RE: 11ITB79910K-NH W042-ALPHARETTA WATER TRANSMISSION MAIN (GAP ON KIMBALL BRIDGE RD)

**11ITB79910K-NH W042-Alpharetta Water Transmission Main (GAP on Kimball Bridge Rd)
Addendum No. 3**

The following information is offered in response to questions and requests for clarification.

FULTON COUNTY STANDARD DETAIL 109
PAVEMENT CUT REPAIRS
TYPE A, B & C

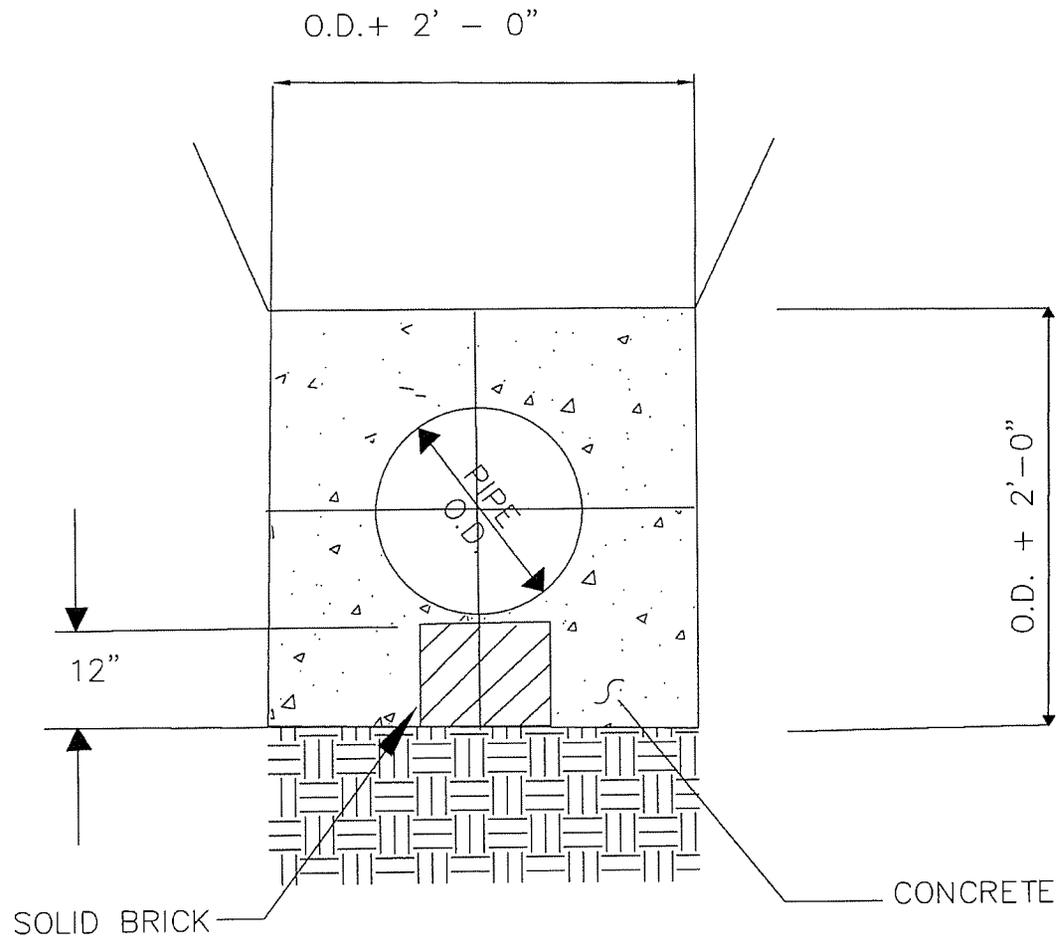
Question 6: What is the correct paving section that will be placed in the road? The type C detail call for 18" of flowable fill with 1.5" of asphalt on top of that. Is that the detail that will be used?

Question 11: The pressure pipe detail shows the 18" concrete and asphalt patch for the width of the ditch while the pavement patch detail Type C has a one foot cut out on each side of the trench. Which is the correct width for payment?

Answer: Correct.

Answer: Type C detail is the correct detail.
